DEVELOPMENT APPLICATION ASSESSMENT REPORT

Application Number:	DA2024/1295
----------------------------	-------------

Responsible Officer:	Phil Lane
Land to be developed (Address):	Lot 12 DP 31294, 7 Crane Lodge Place PALM BEACH NSW 2108
Proposed Development:	Alterations and additions to a dwelling house including secondary dwelling
Zoning:	C4 Environmental Living
Development Permissible:	Yes
Existing Use Rights:	No
Consent Authority:	Northern Beaches Council
Delegation Level:	NBLPP
Land and Environment Court Action:	No
Applicant:	Alexei Mazin

Figure 3 - Original proposal

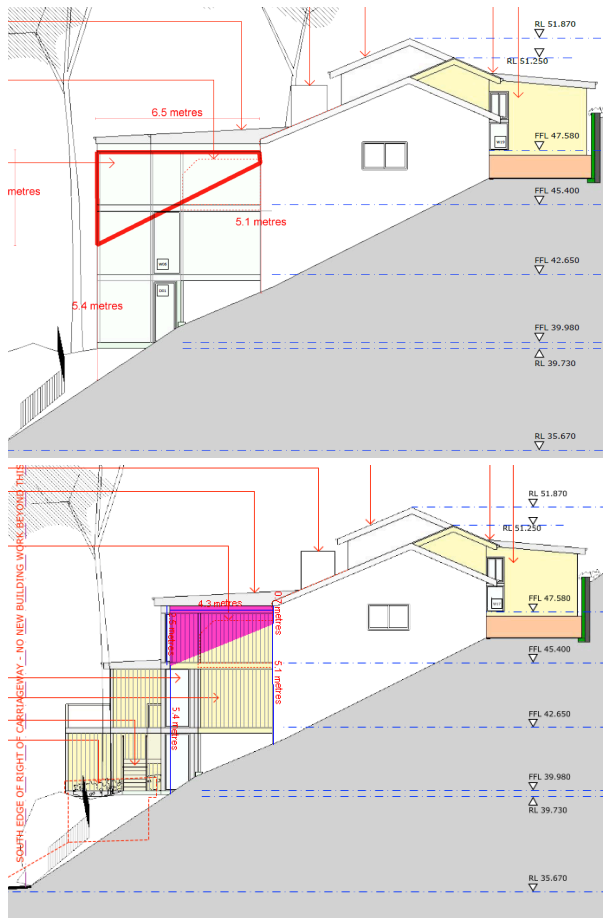
The proposal has been assessed against the relevant provisions of the PLEP 2014 and P21 DCP. The assessment concludes that the amended proposal complies with these requirements (subject to conditions). Where variations to the P21 DCP built form controls exist, they have

The Level 2 deck includes a proposed solid wall, which is required under the National Construction Code (NCC). This is due to the secondary dwelling being located on Level 1, necessitating a building classification change from Class 1 to Class 2.

Figure 5: DP31294 (area (J) access handle for Lot 13 is where the encroachment occurs.

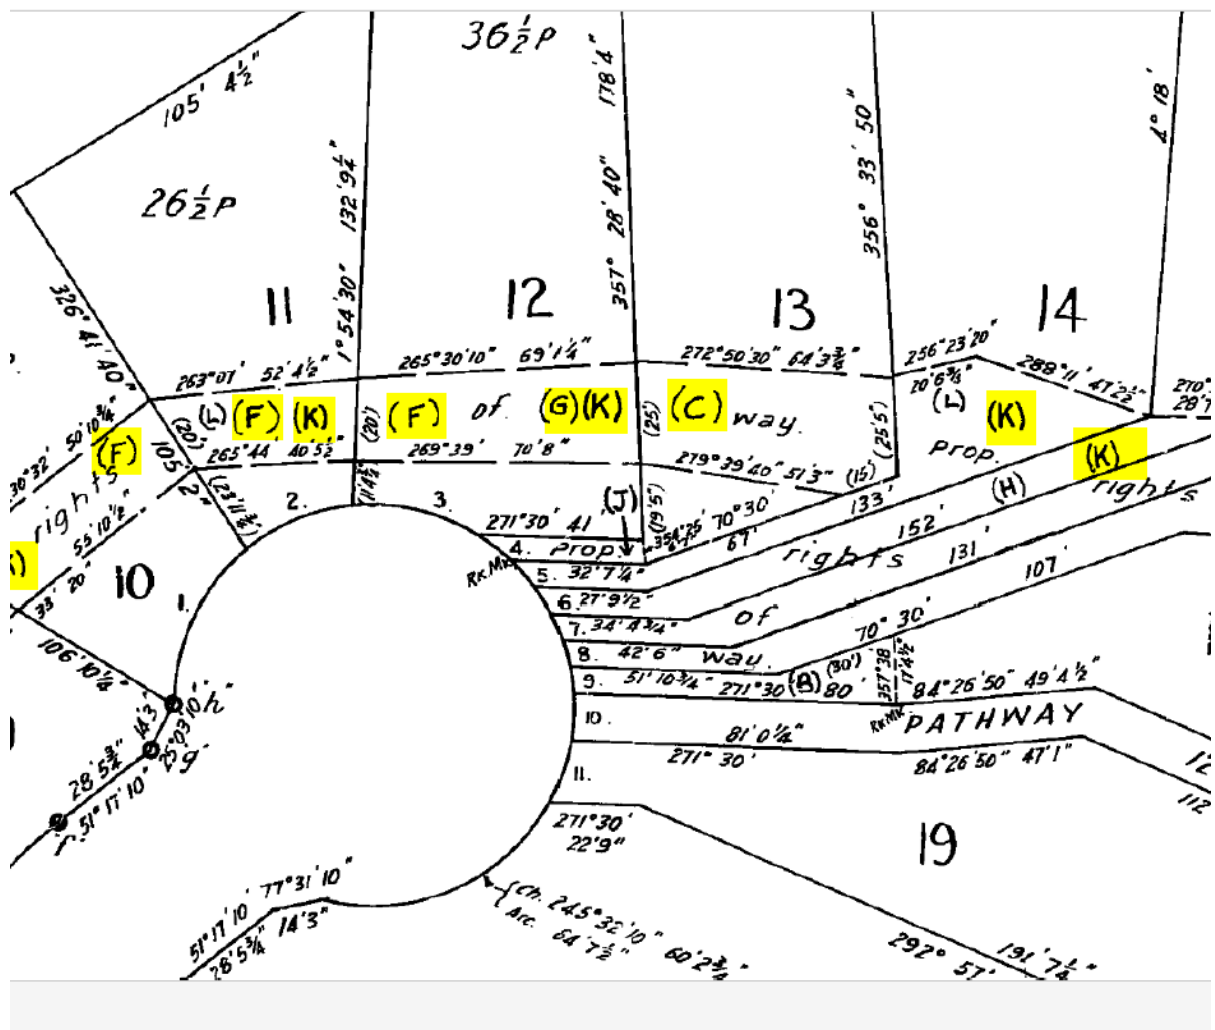
Comment: An issue was raised regarding the proposed alterations and additions to the garage, including increases in width, length, and height.

It is noted that the existing garage currently encroaches over the southern front boundary. As a result, a variation to Clause D12.5 (Front Building Line) of P21DCP is supported in this instance. Reviewing the deposited plan (DP31294) is noted that the existing garage on subject site on Lot 12 (7 Crane Lodge Place) encroaches on to Lot 13 (8 Crane Lodge Place) see plan below:-

Based on the information above Council cannot approve any alterations and additions to the garage without owner(s) consent from Lot 13 (8 Crane Lodge Place). Council received an email on 1 April 2025 from the owners of 7 Crane Lodge Place removing the garage from this development application. A condition will be included to ensure this outcome.

Figure 6 - Proposed modified garage

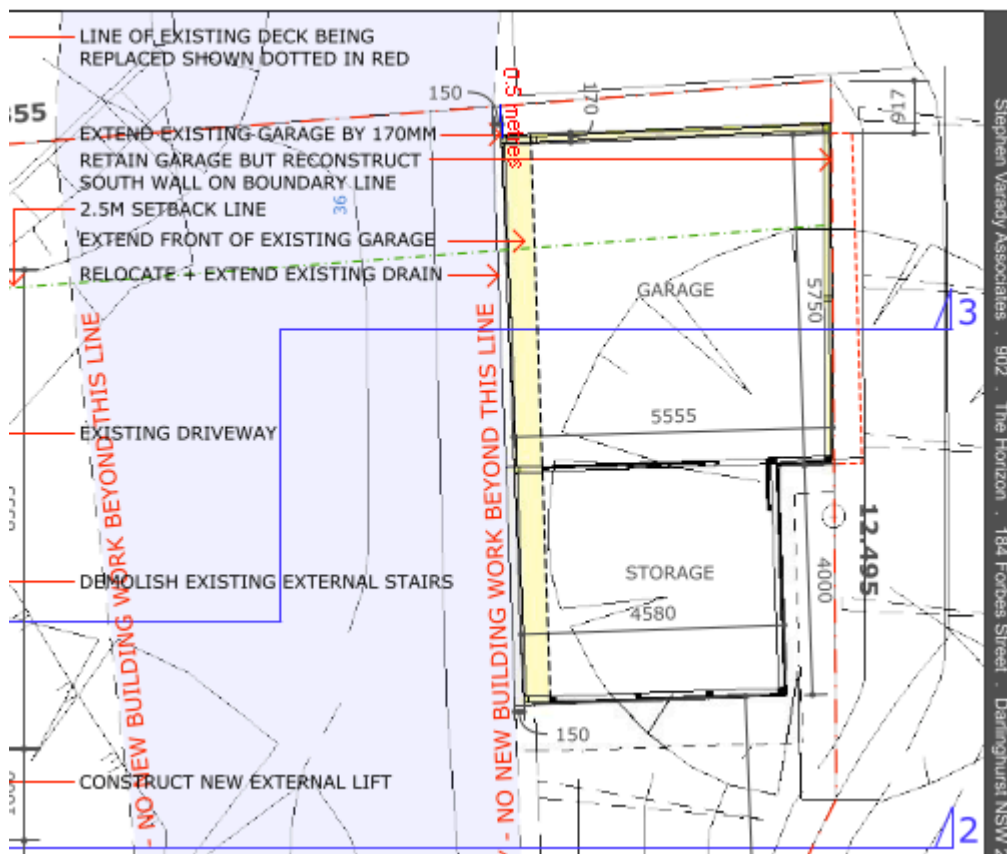
The proposed garage is located nil setback from the front boundary, presenting a variation of 100% (6.5m).

Reviewing the survey submitted with the development application it is noted that the existing garage hangs over the southern front boundary and these proposed works will rectify this encroachment.

Figure 7: Proposed Level 3 Floor Plan

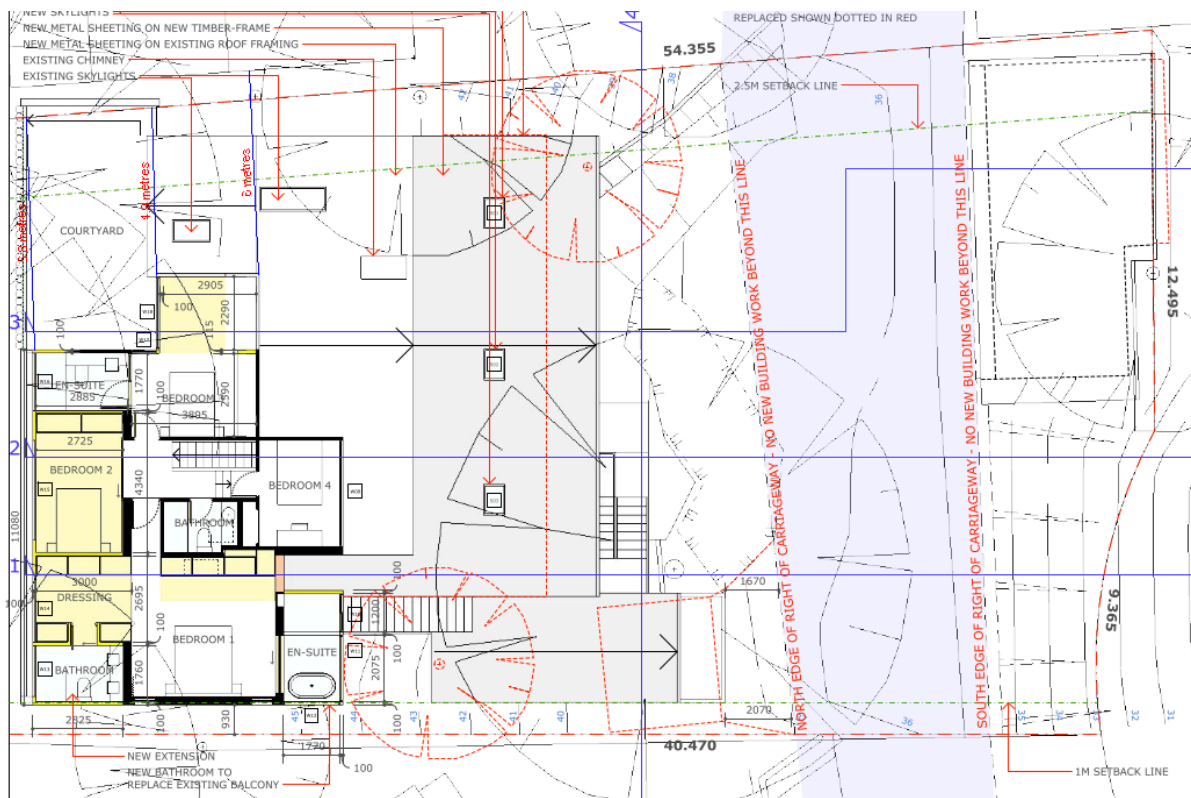
Pursuant to Section D12.6 of the Pittwater 21 Development Control Plan, the minimum side building line for built structures is 2.5m to at least one side and 1m for the other side.

For this site, the 2.5m requirement is taken to be for the eastern boundary and the 1m requirement is taken to be for the western boundary. The existing dwelling has a side setback of 0.93m from the western side boundary and the proposed extensions of level 3 (north western corner of the dwelling) proposes to maintain this existing side setback of 0.93m, which is variation of 7%. It noted all new works on the western elevation maintain a 1m side setback or greater demonstrating compliance with this control.

Figure 12 - Eastern elevation (pink indicates side boundary breaches)

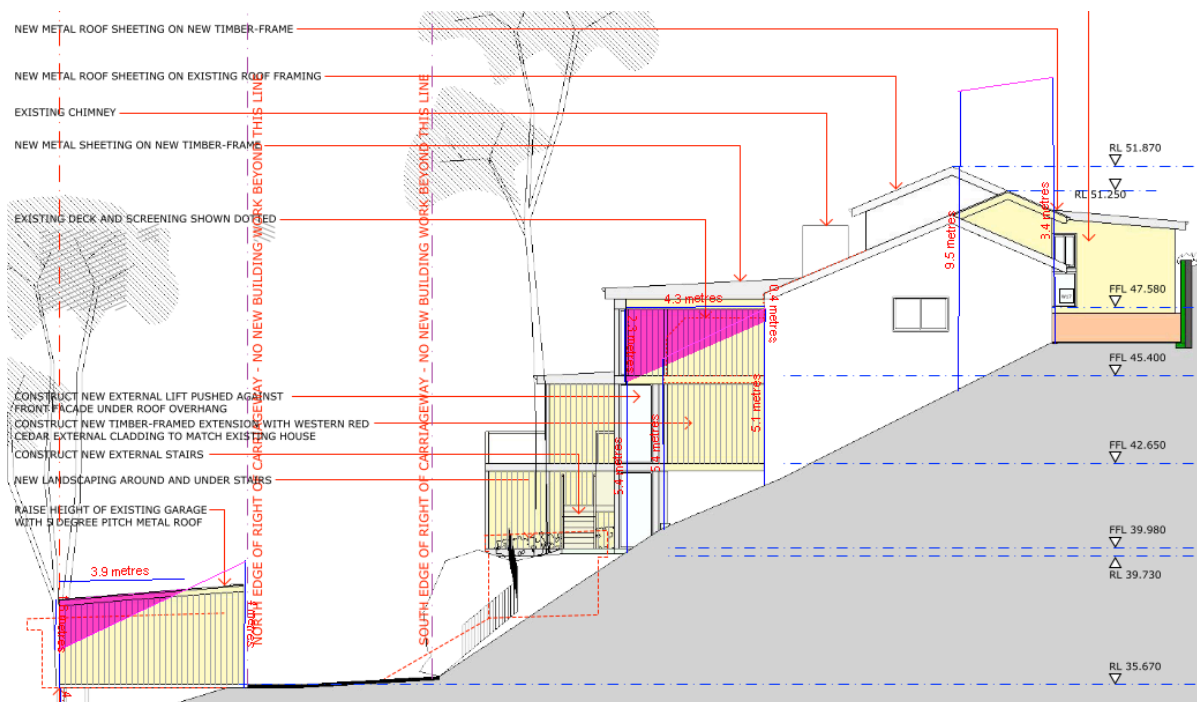
The existing dwelling has an existing side setback of 0.9m and the existing garage has side setback of 0.735m from the eastern side boundary. The proposed new side setback to the garage will be 0.5m - 0.917m (a variation of 63.3% - 80%) and the proposed additions (both levels 1 and 2) to the dwelling will be sited 1.6m - 1.9m (a variation of 24% - 36%) from the eastern side boundary.

Figure 13 - Proposed Site Plan & Landscape Open Space Calculations

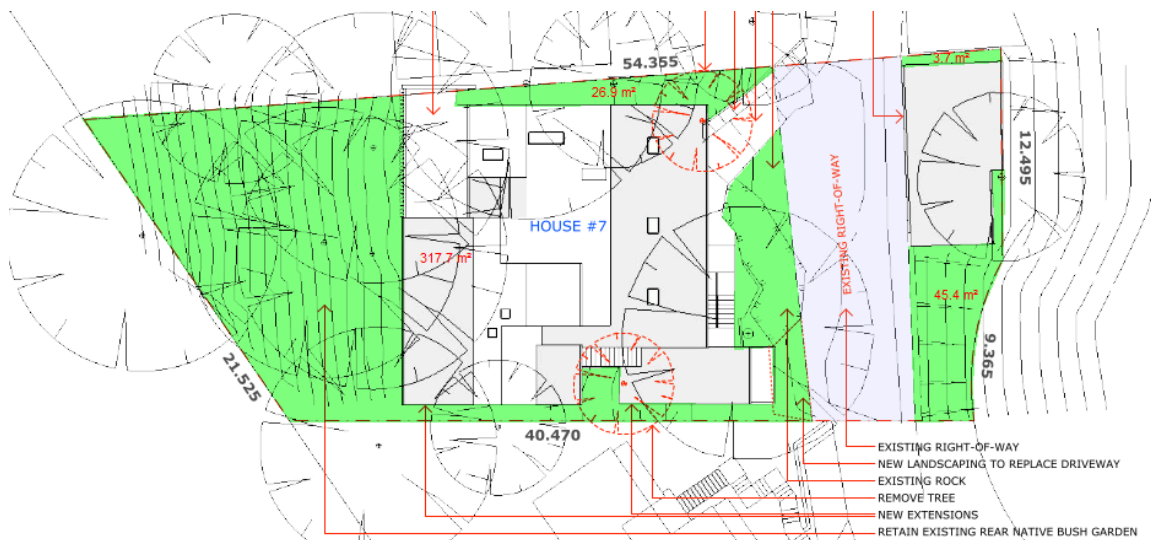
The variations provision of the control allows for impervious areas less than 1m wide and up to 6% (57.5m²) of the site area to be counted as impervious landscape treatment, provided the outcomes of the control are achieved and such areas are used for outdoor recreational purposes only.

Upon application of the variations the proposal provides a landscaped area of 47.1% (451.2m²), representing a 21.5% (123.6m²) variation to the control. It is noted that the existing right-of-carriageway (minus natural features and other man-made structures) occupies 14.3% (137.2m²) of the subject site.
